ABINGTON TOWNSHIP

PLANNING COMMISSION MEETING

- a. Review and approve the minor Land Development application, LD-22-04 - 521 Moredon Road (Solar Array Panel).

We have received a copy of the Preliminary/Final Minor Land Development Plans (3rd Submission) consisting of fifteen (15) sheets dated July 16, 2022 and received on August 17, 2022; as prepared by Boles, Smyth Associates Inc., located at 2400 Chestnut Street in Philadelphia, PA for the above referenced project.

SHEET:
**Property Plan
Record Plan**

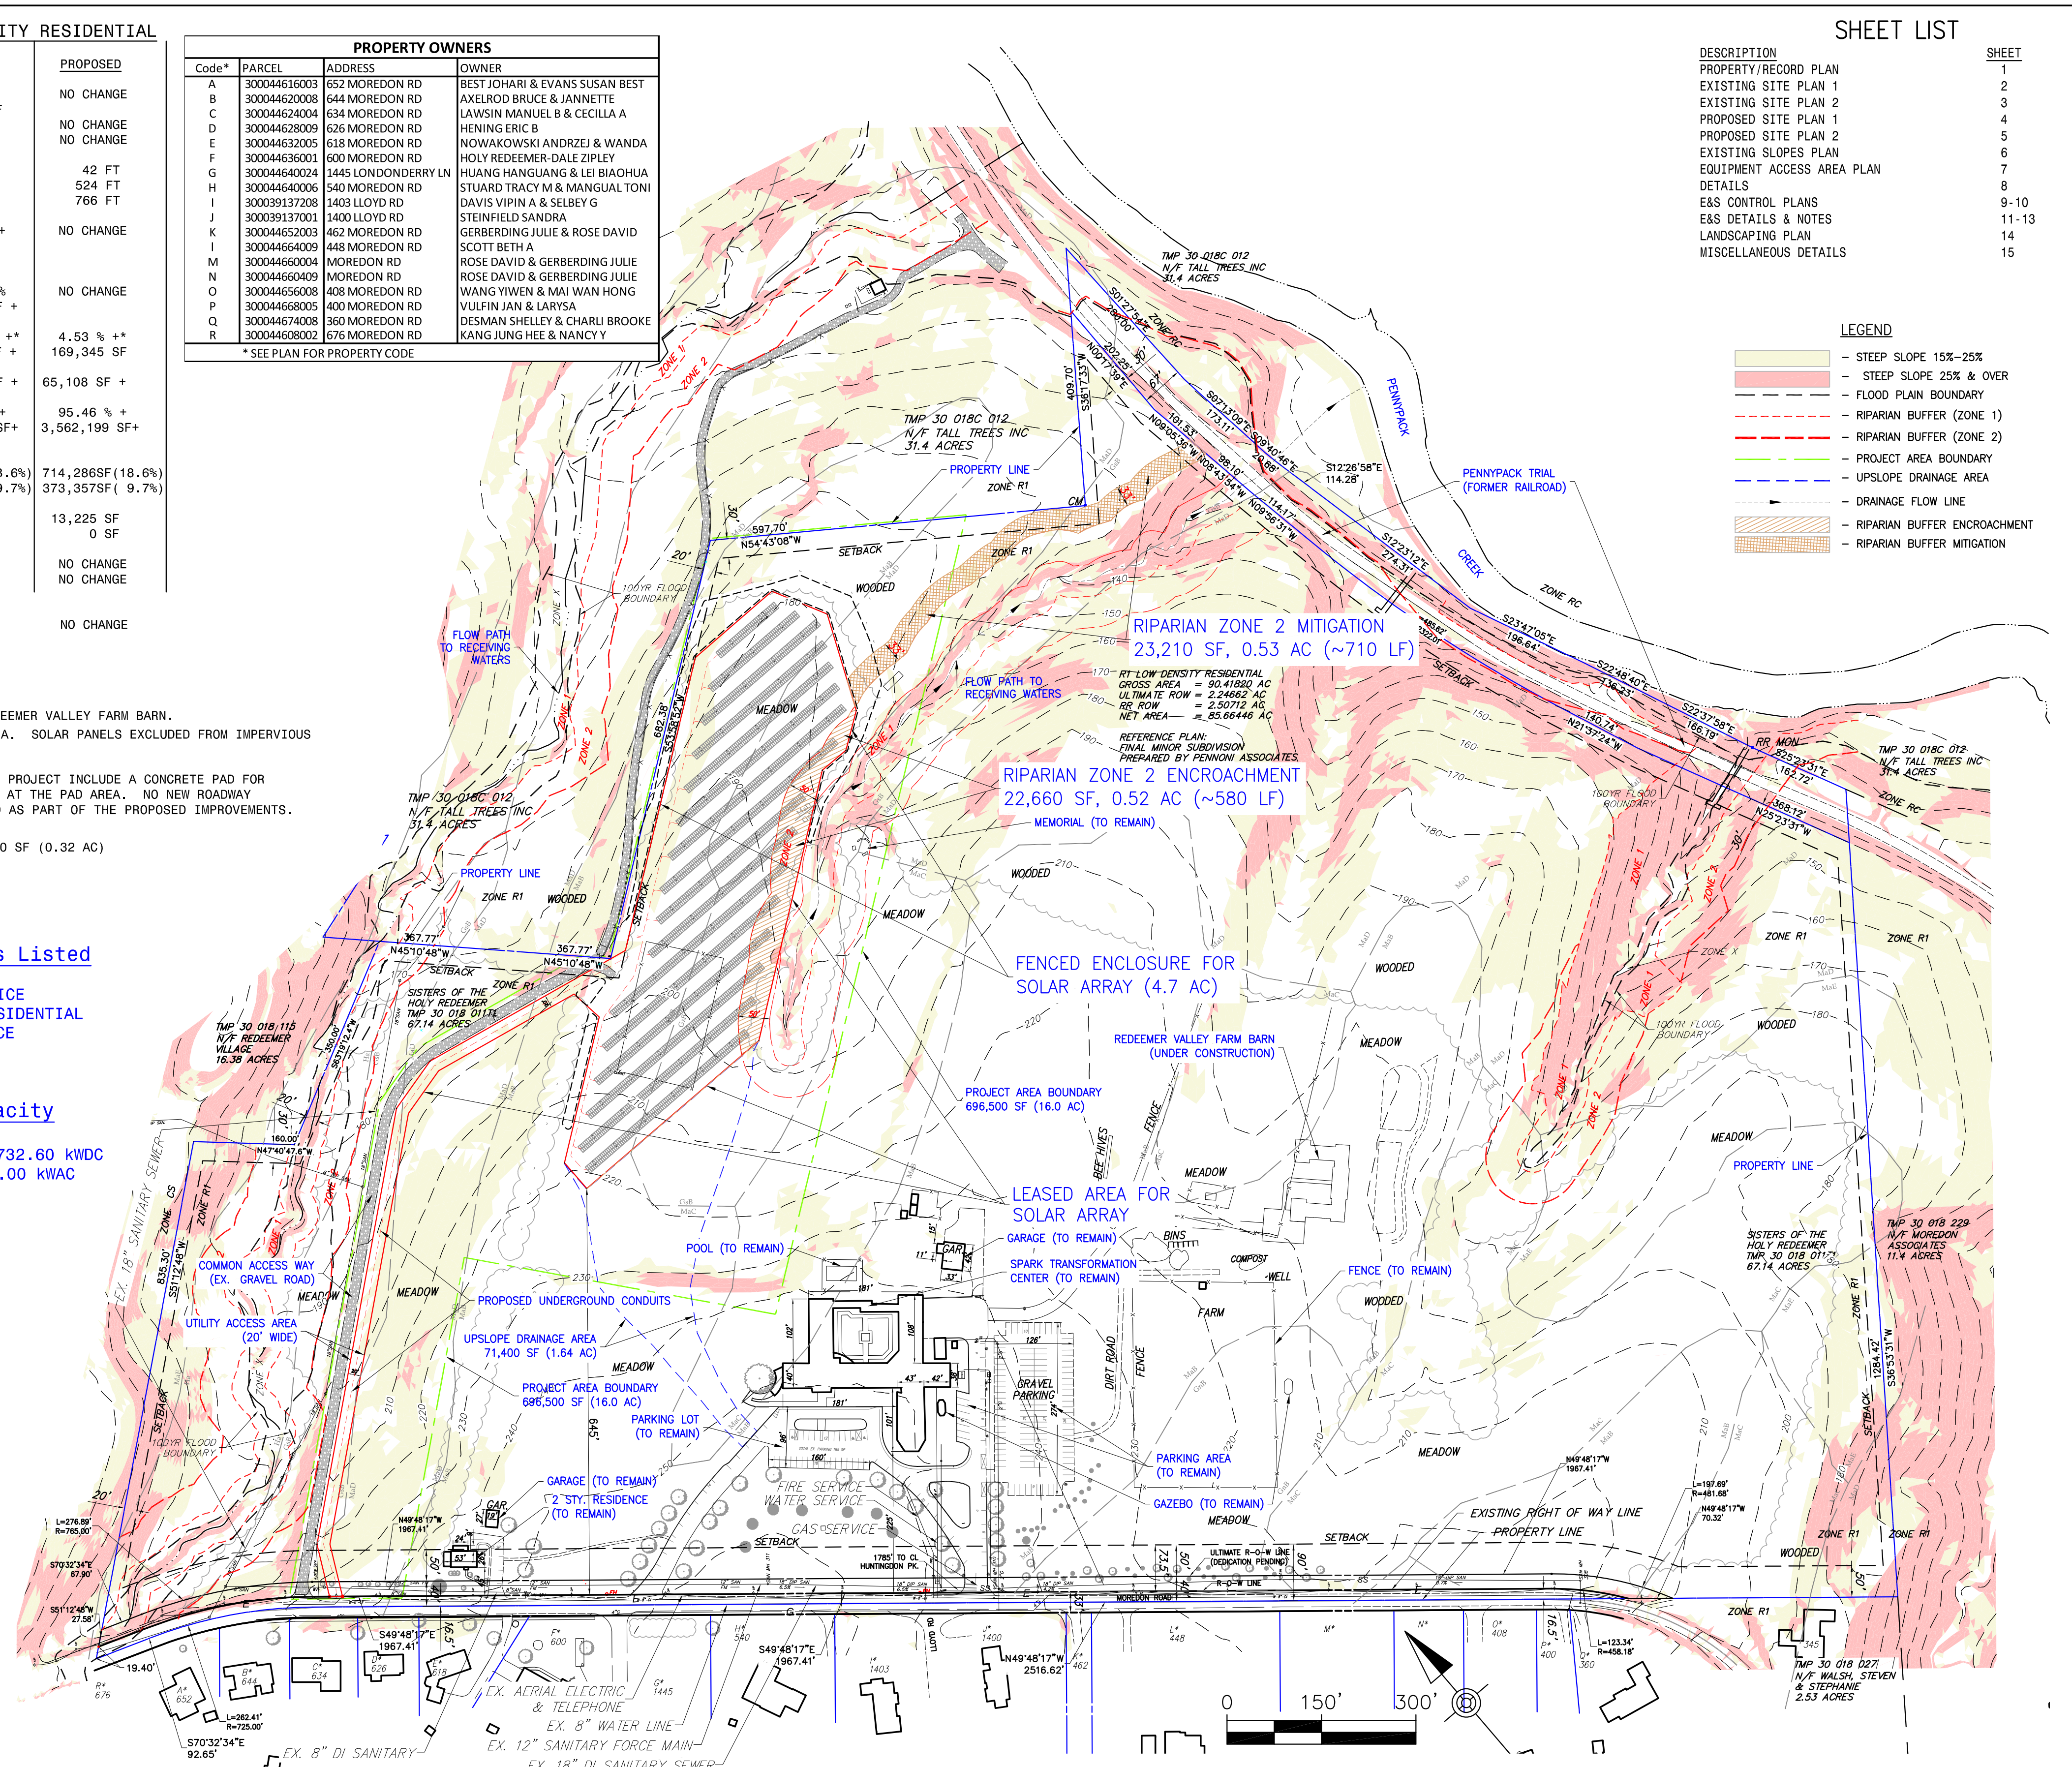
The Applicant shall add a note on the Record Plan (Sheet 1) stating the above requirement.

CONCRETE CURB LEVEL SPREADER

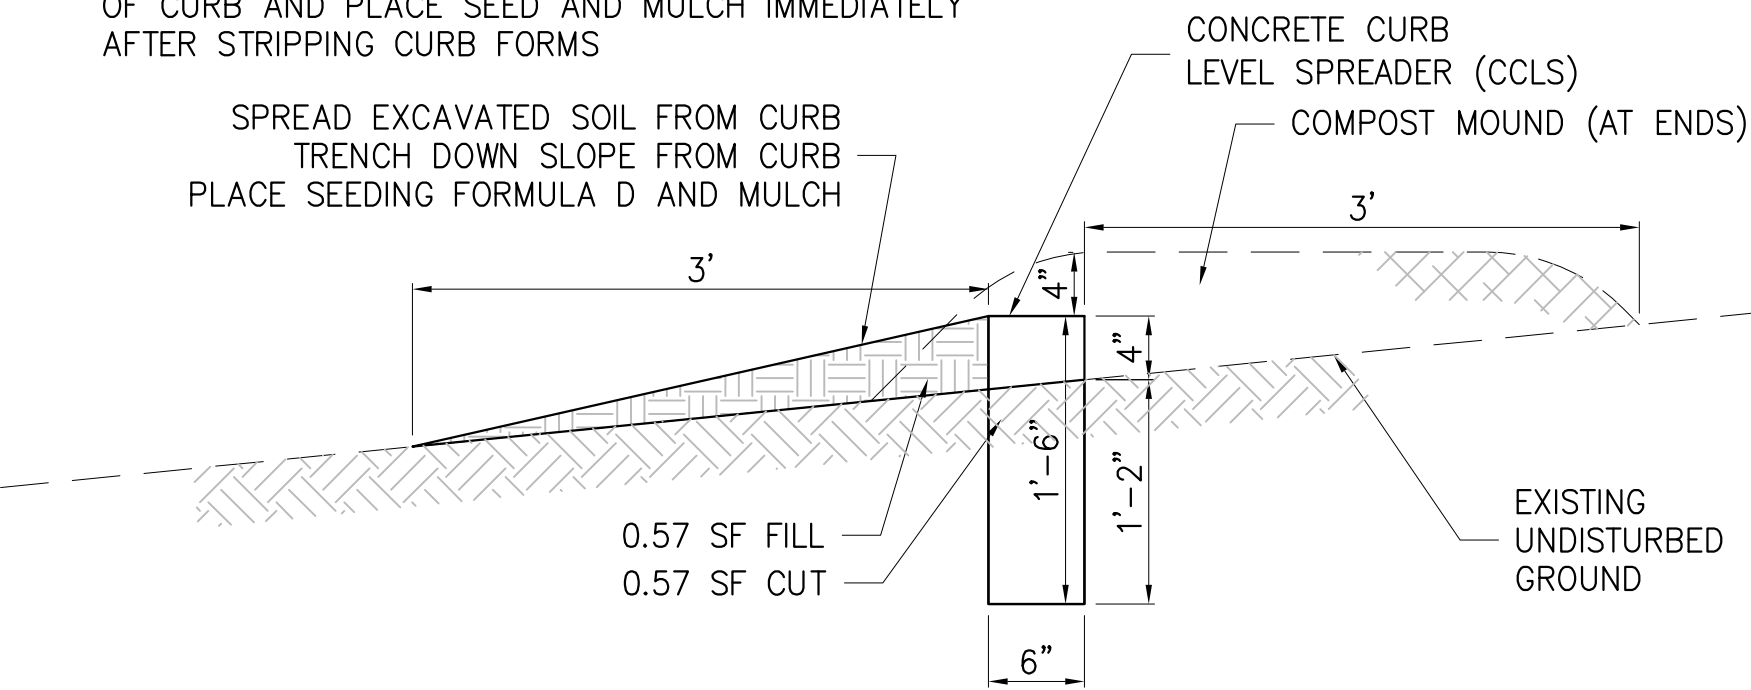
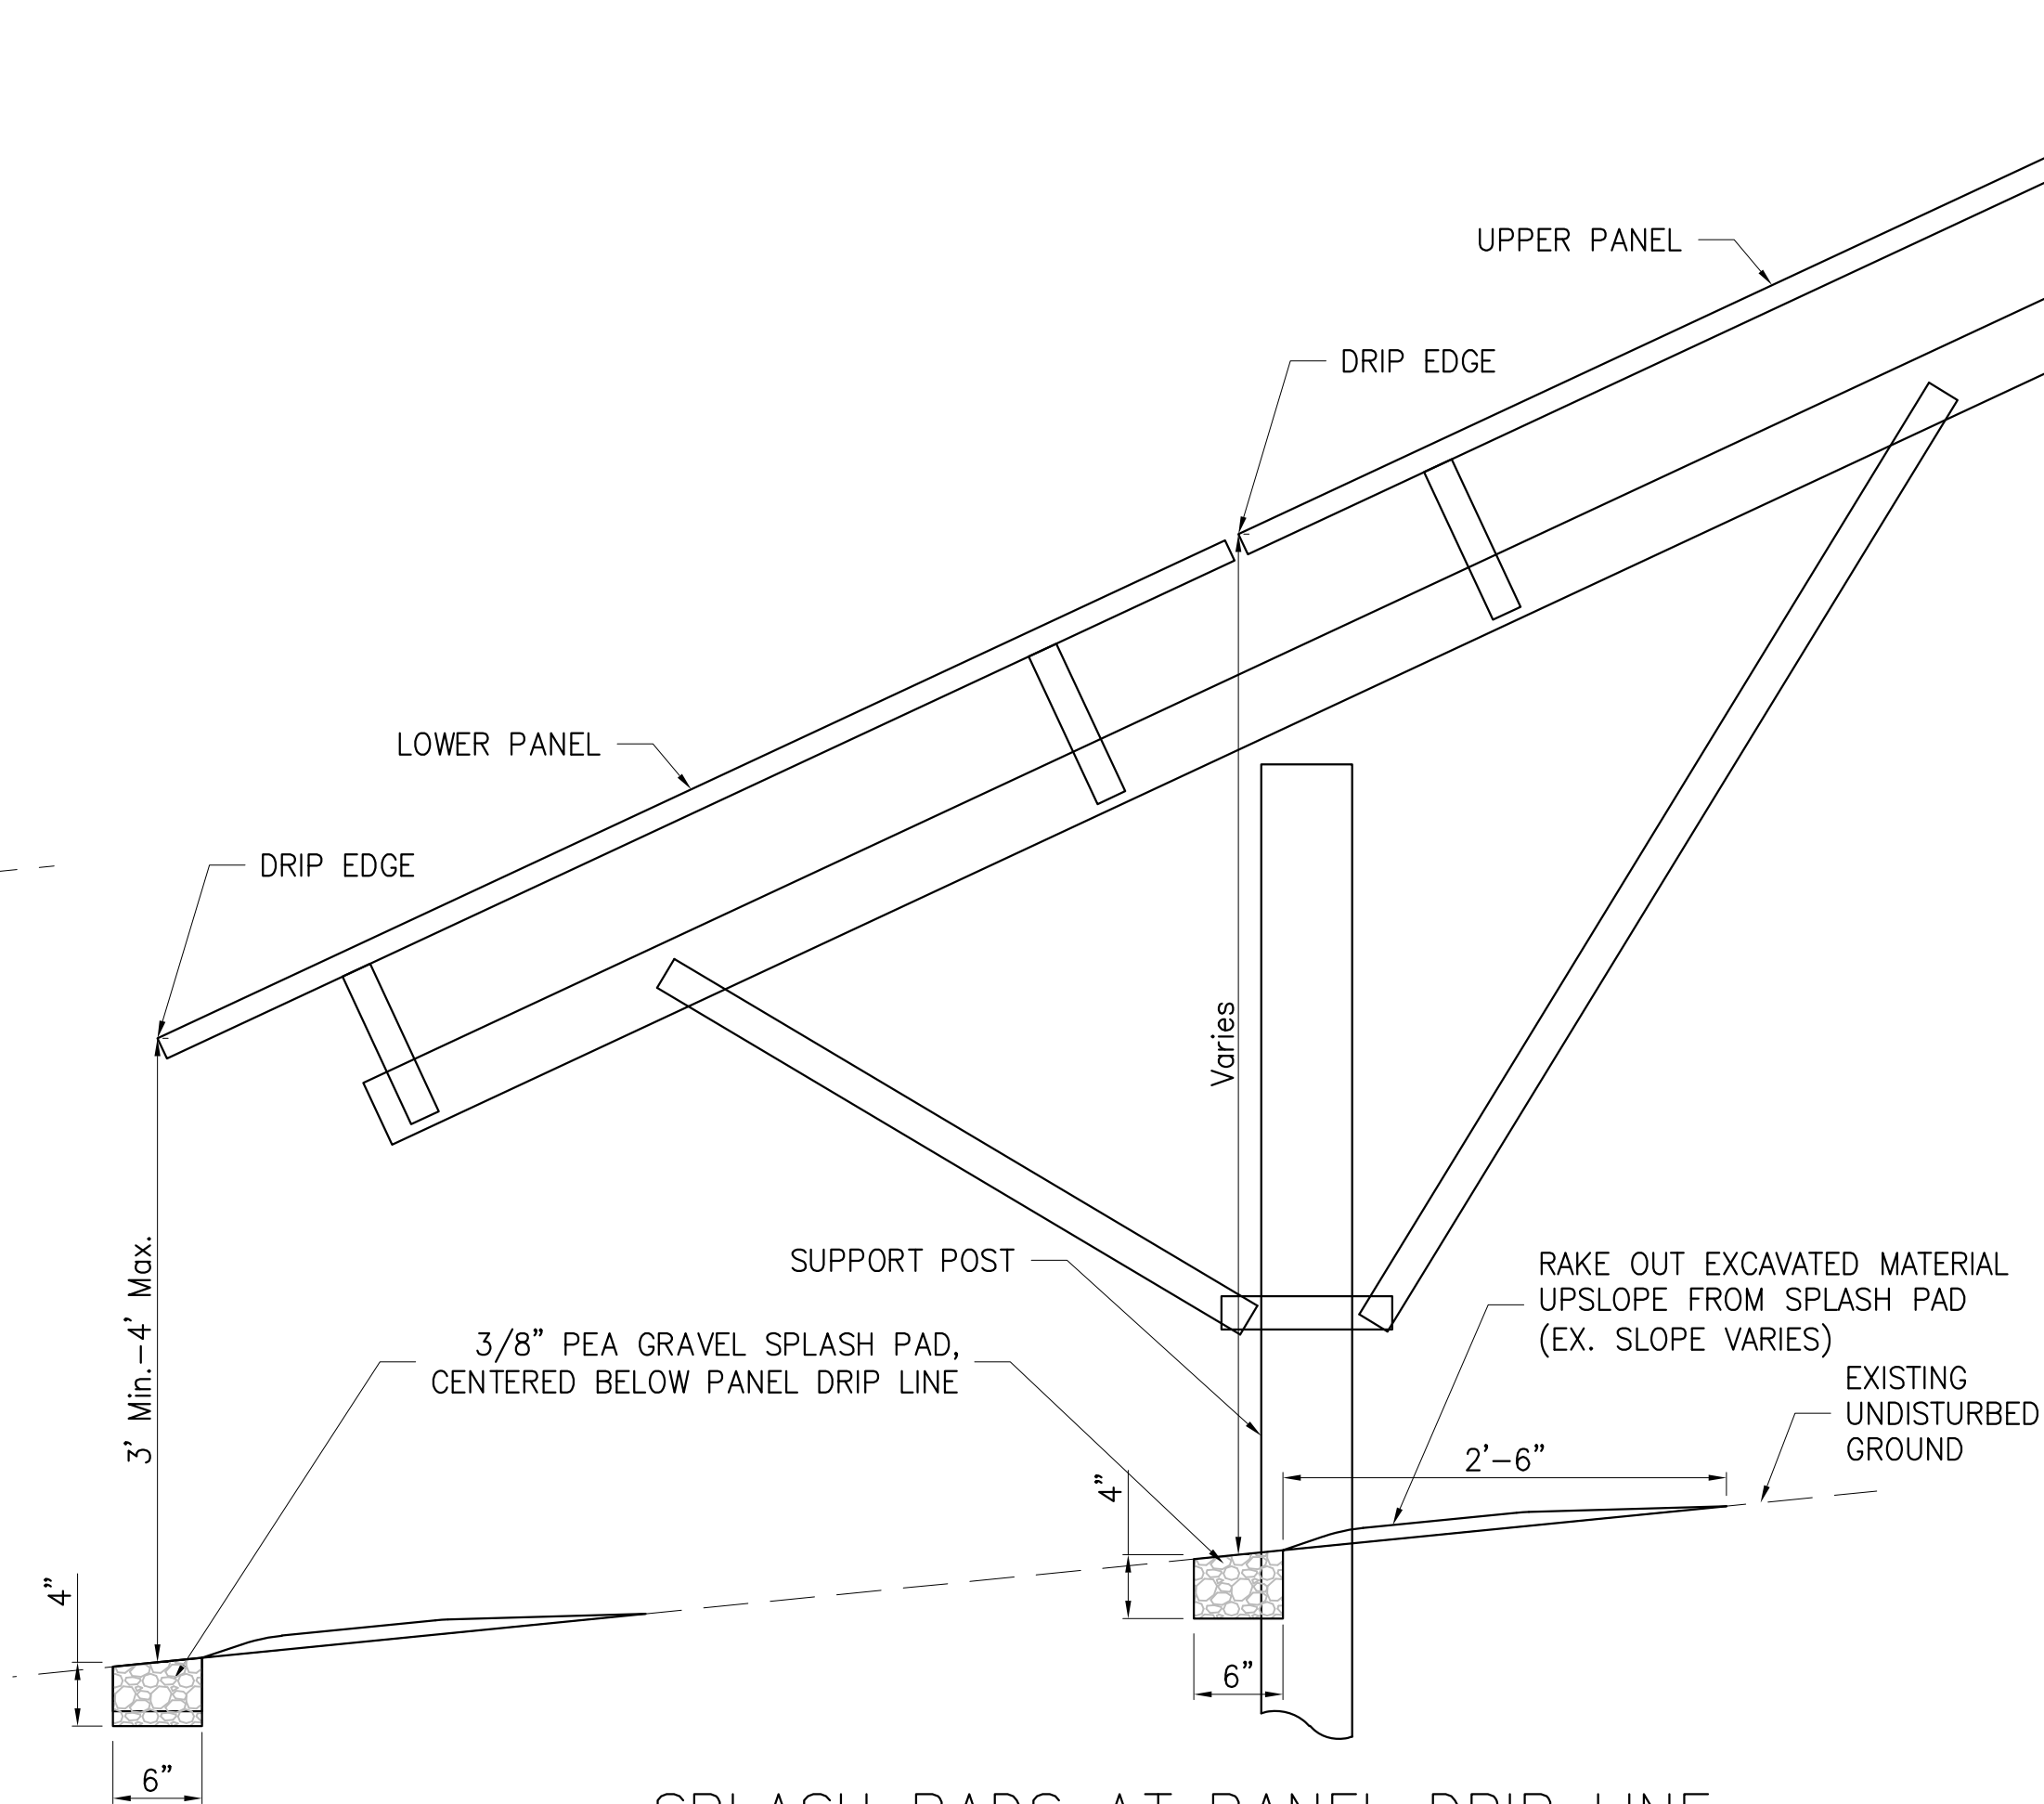
1. **§142 – Stormwater Management** – A waiver from the requirement to provide stormwater management design report and calculations for the solar panel array.
The Applicant is proposing concrete curb level spreaders for the solar panel array which will help reduce the velocities of the flows leaving the site. Stormwater management is provided for the 3,300 SF of new gravel area as required by the code.
